H22-19
Hotel Redevelopment
REVISED

Property Owner: Legacy Hotel of Medina LLC
Applicant: Jim Gerspacher
Location: 253 and 257 South Court Street
Zoning: C-2 (Central Business)
Request: Certificate of Appropriateness revisions for the construction of a hotel

The current application revises the footprint and height of the hotel building, updates building elevations, and provides greater detail. The proposed revision does not alter the previous approval regarding the demolition of two existing buildings at 253 and 257 South Court Street or application H24-06.

This letter is regarding the proposed hotel on parcel 028-19A-21-397. Our team has been working on adjustments to the overall building design to improve constructability, enhance the floor plans for both operational efficiency and guest experience, as well as enhance the exterior design and compatibility within the Historic District.

2 PLAN ORIGINAL ROOF PLAN OUTLINE AND HEIGHTS
1" = 20'-0"

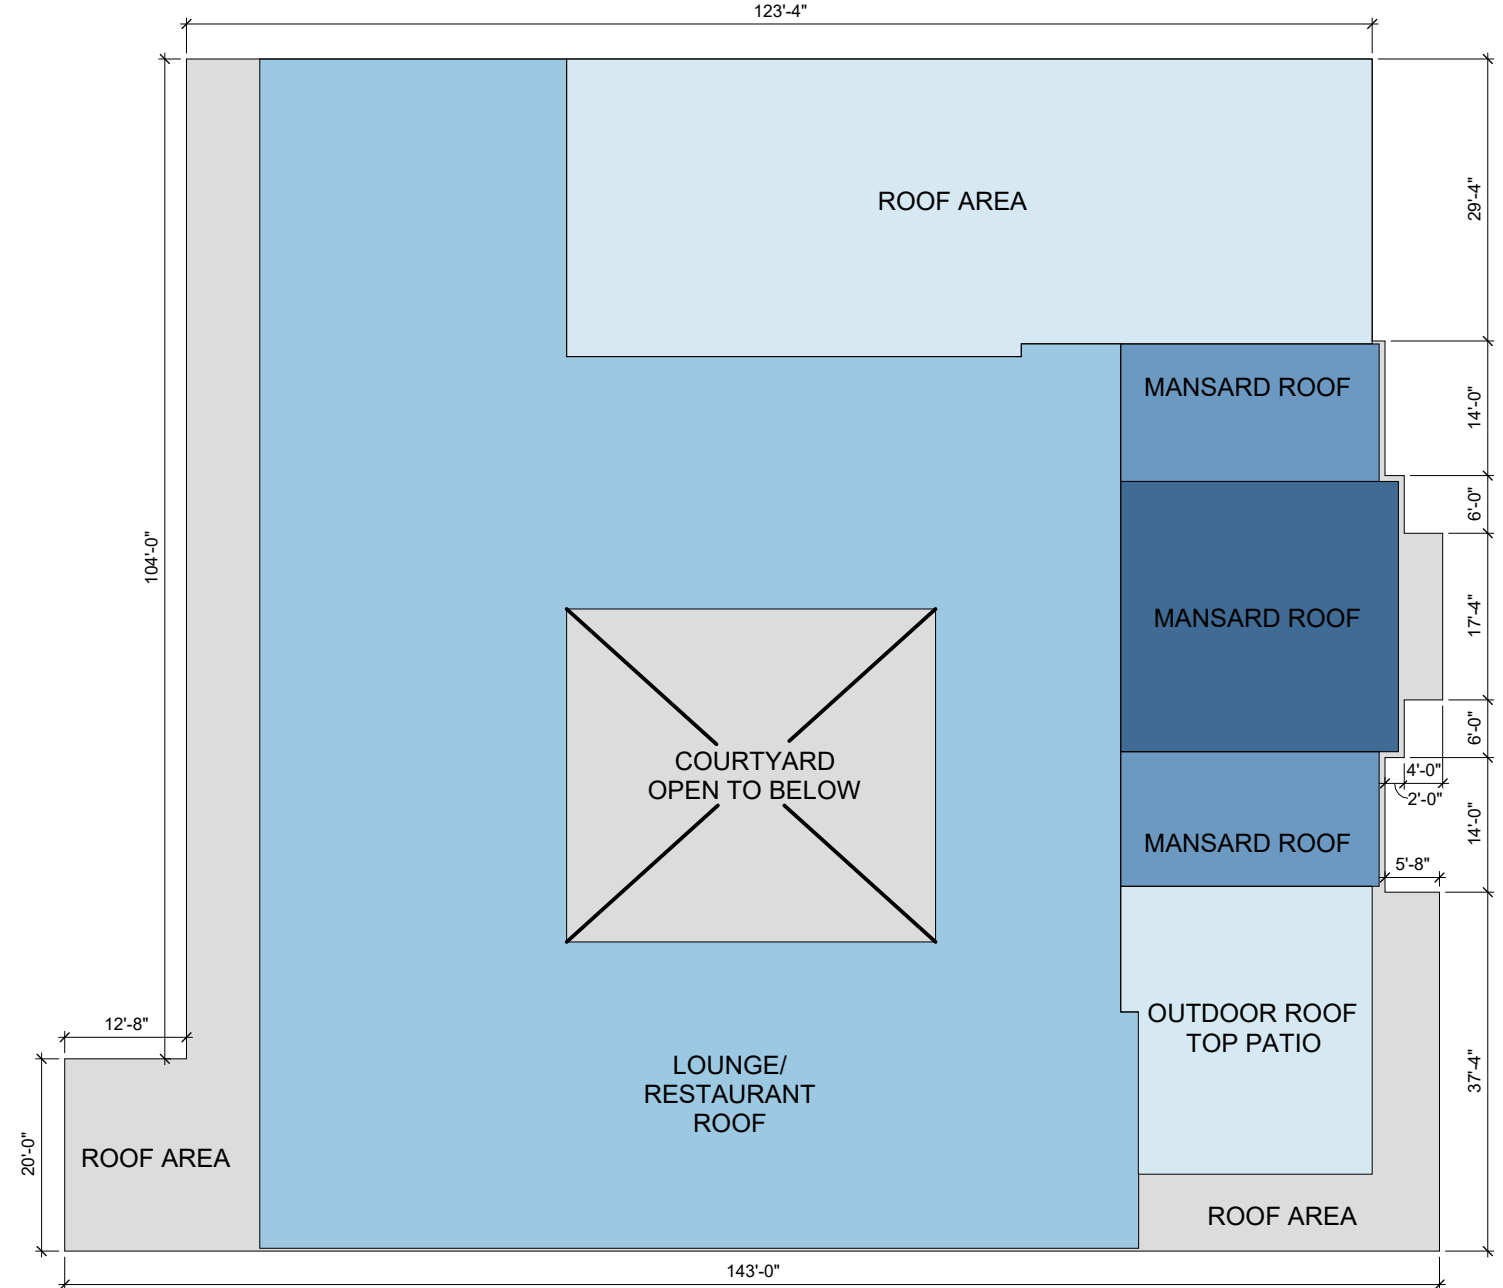
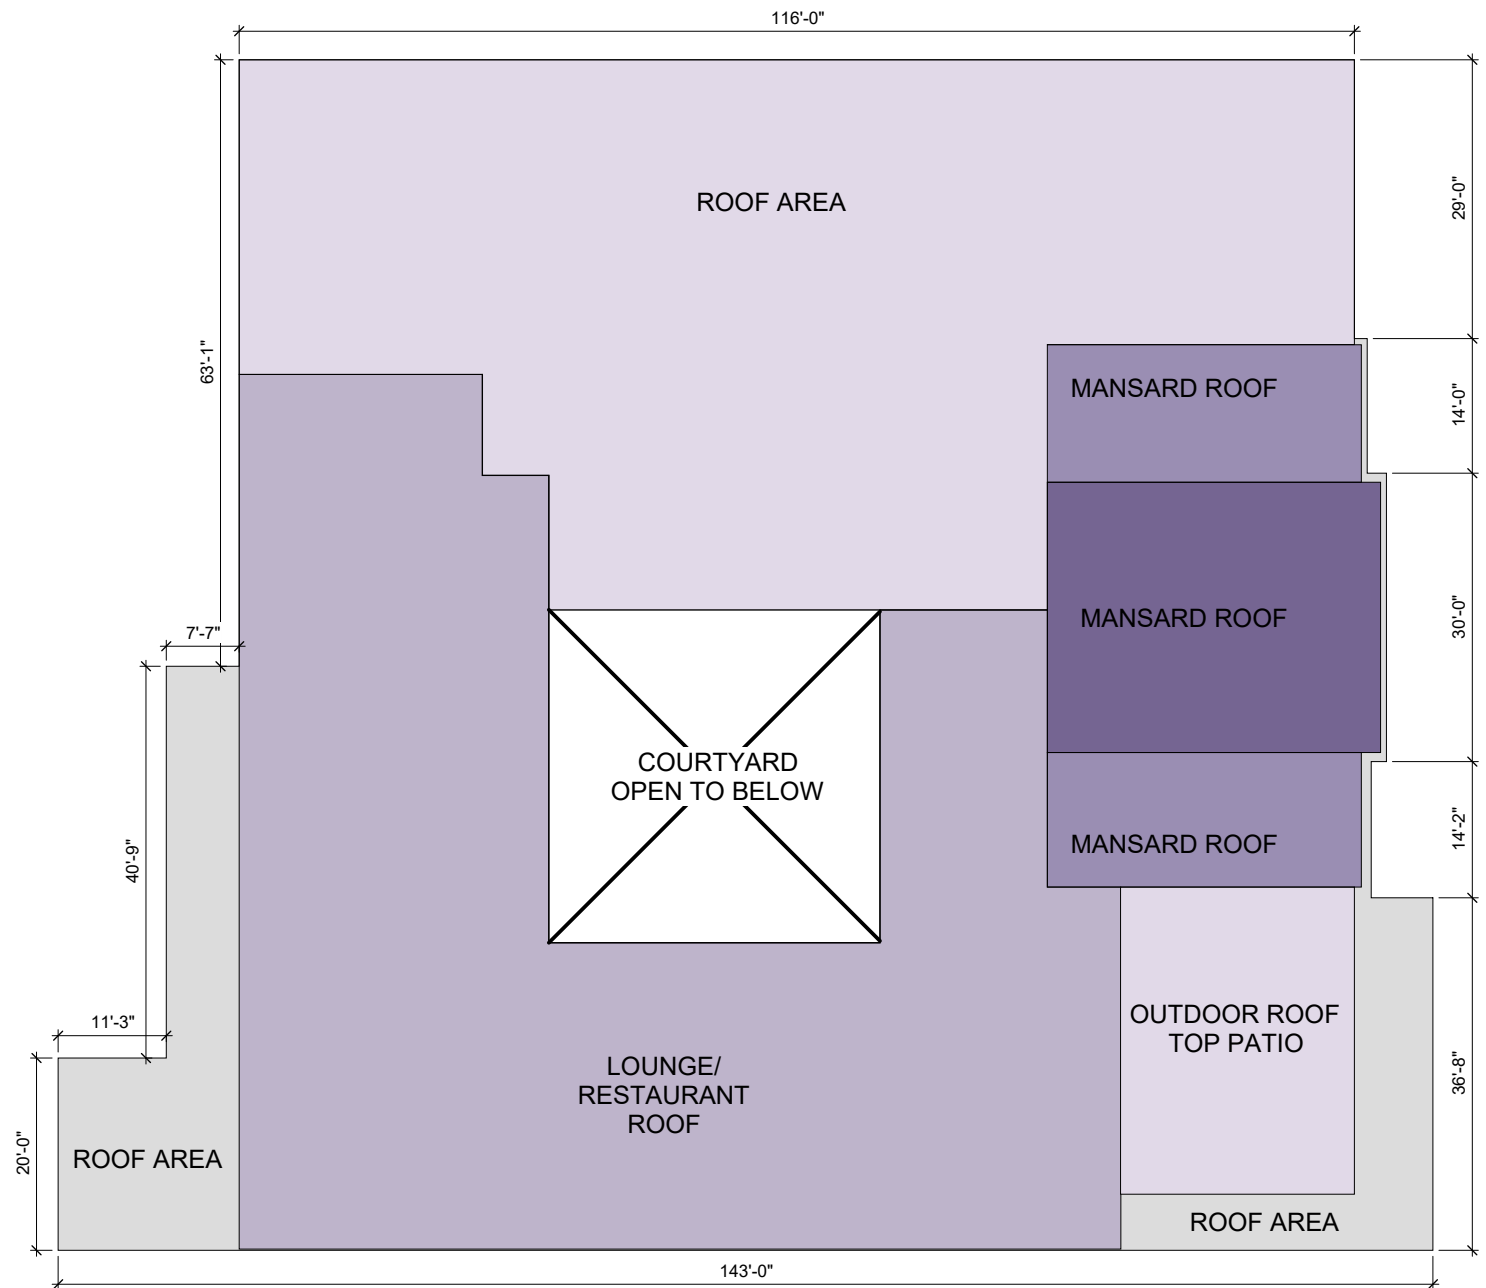
- 2- Height increase: the original approved elevations show the top of roof at 55'-0", the updated drawings show 61'-0". The additional height requested is 6'-0" higher than the previously approved plans. This increase in floor height accommodates more advanced HVAC systems than previously approved without sacrificing quality of interior spaces. Unlike the previous design, no suites will have exterior louvered grilles on the newly proposed plans. Without the new height variance, the available methods of construction are narrowed to options that are not as feasible and accommodating mechanical duct work becomes difficult.

The mansard roof was previously approved at 66'-8", the proposed is at 71'-0". This is purely an architectural feature that gives the hotel its historical character and is visible on S Court Street from all sides. The added height is not being used to generate profit to the developer(s).

1 ELEVATION HOTEL - WEST ELEVATION

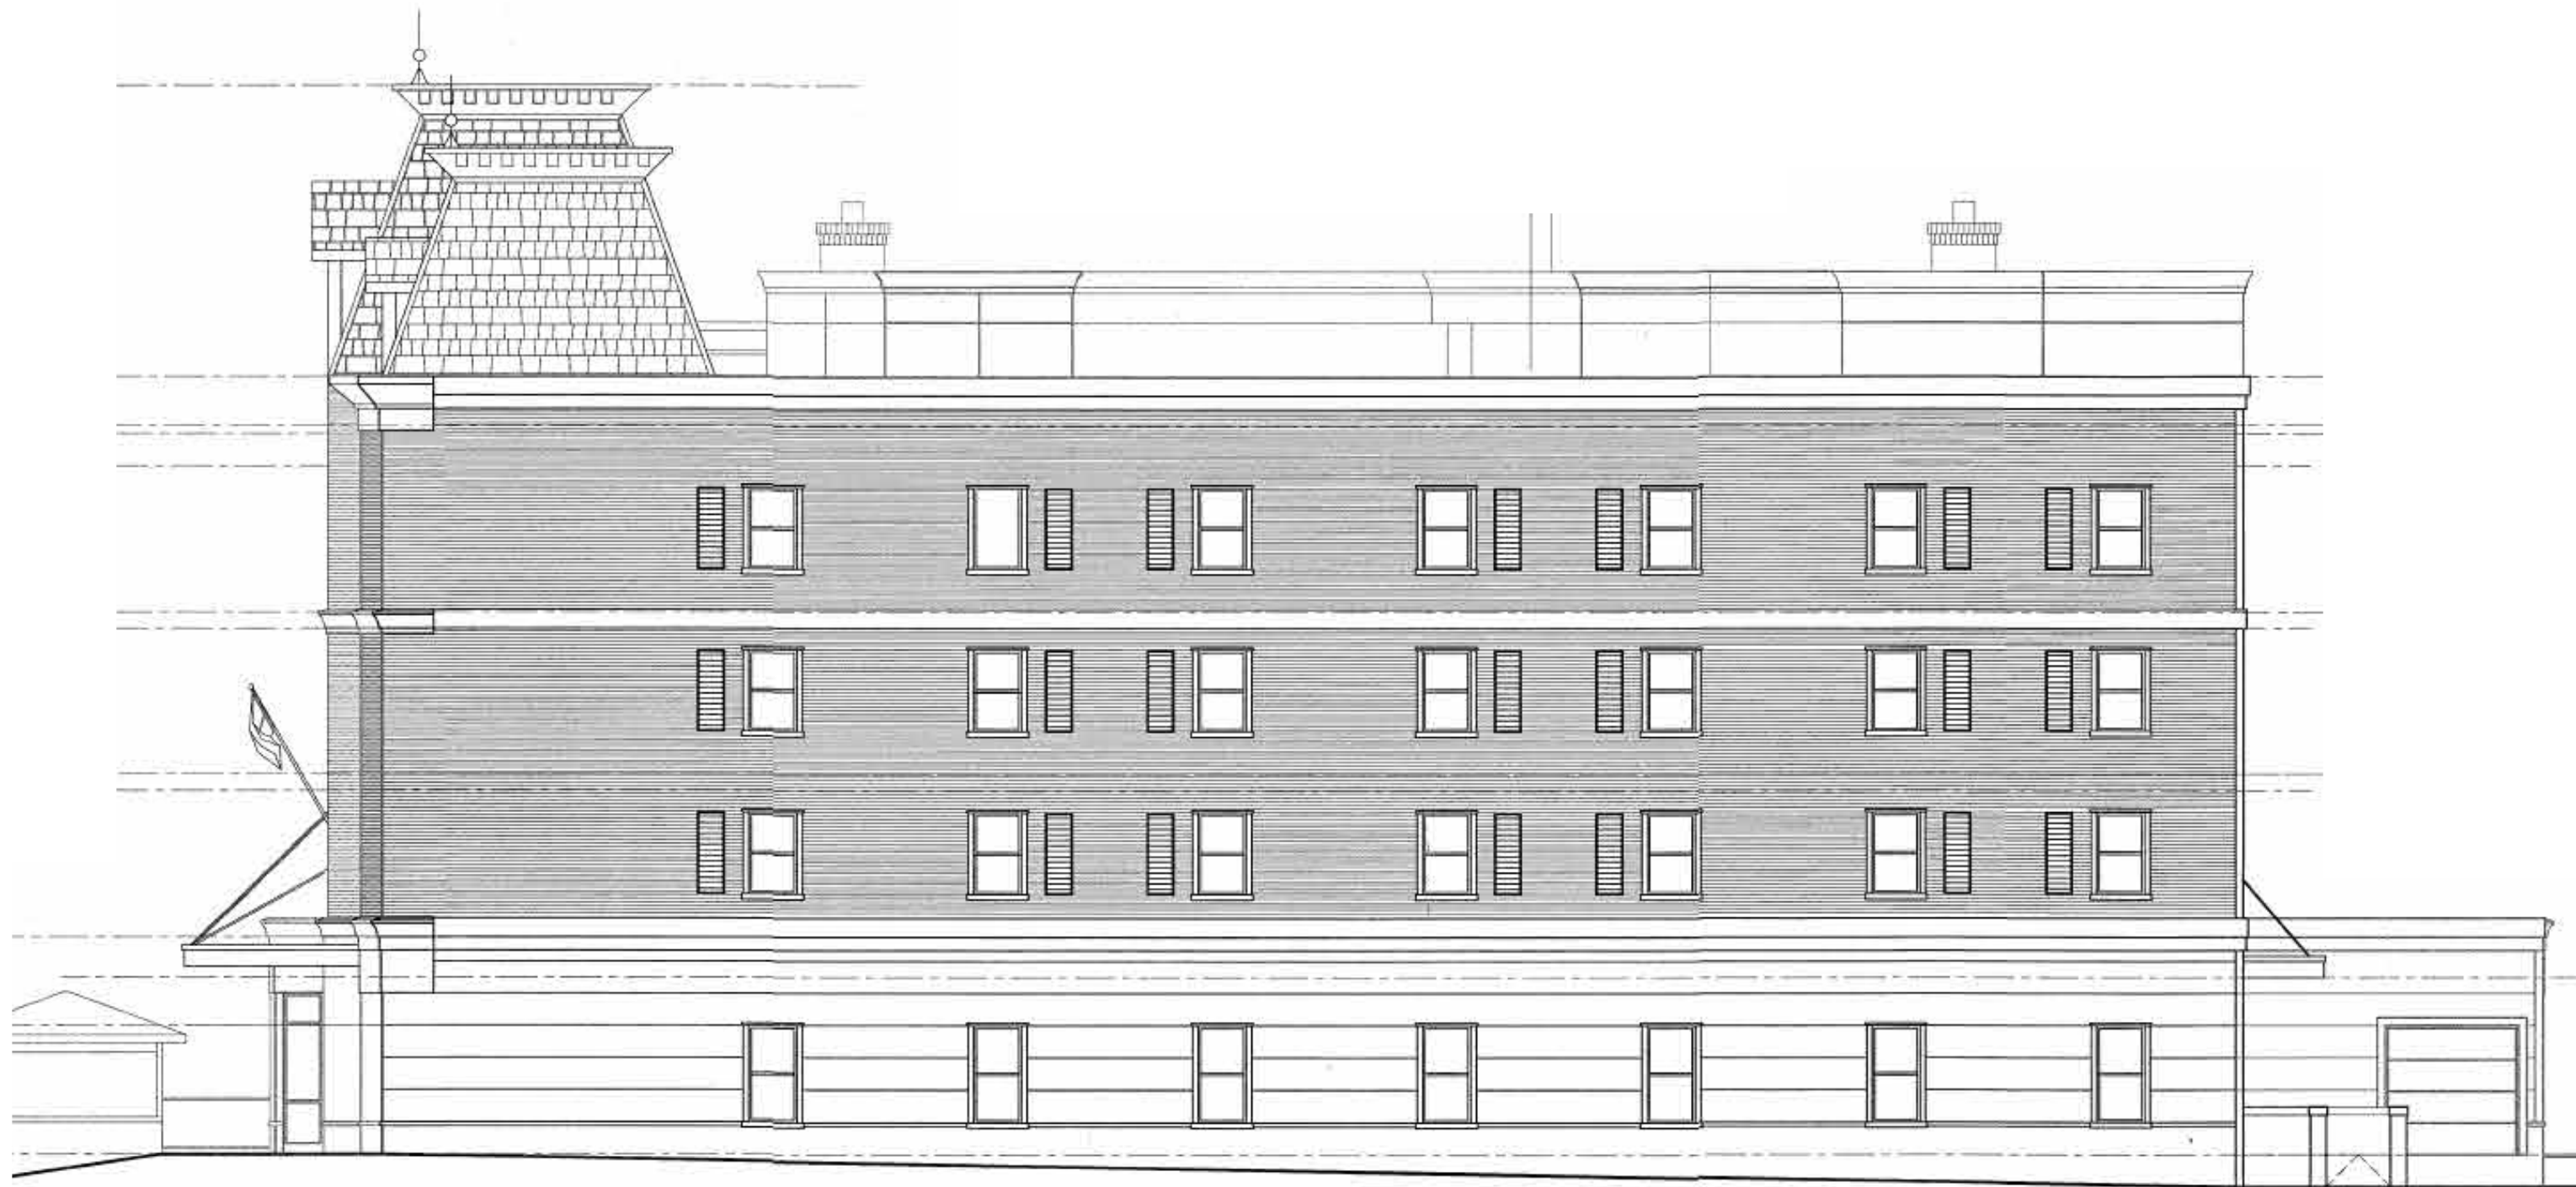
Additional windows have been incorporated on all building elevations with a modified design. This alteration appears to be more consistent with window sizes and styles in the area. In addition, louvers have been removed from the side and rear elevations.

- 1- Brick detail added on all facades, especially primary façade (Brick reveals and soldier courses)
- 2- VTAC louvers have been eliminated on north and south facades.
- 3- Window size and shape: In the previously approved design, each hotel suite has a single wide and low window. The proposed design replaces that single window with two tall and slender windows per suite to better fit proportionally within the context of Medina's Historic District.
- 4- Replace the use of EIFS with Fiber cement (for maintenance and durability purposes - similar color) on the fifth floor.
- 5- The front canopy is reduced in size.
- 6- Cornice updates: We have assigned Sherwin William color codes to the previously submitted cornice colors to better define the selections. We have also updated the configuration of the colors on the cornice profiles.
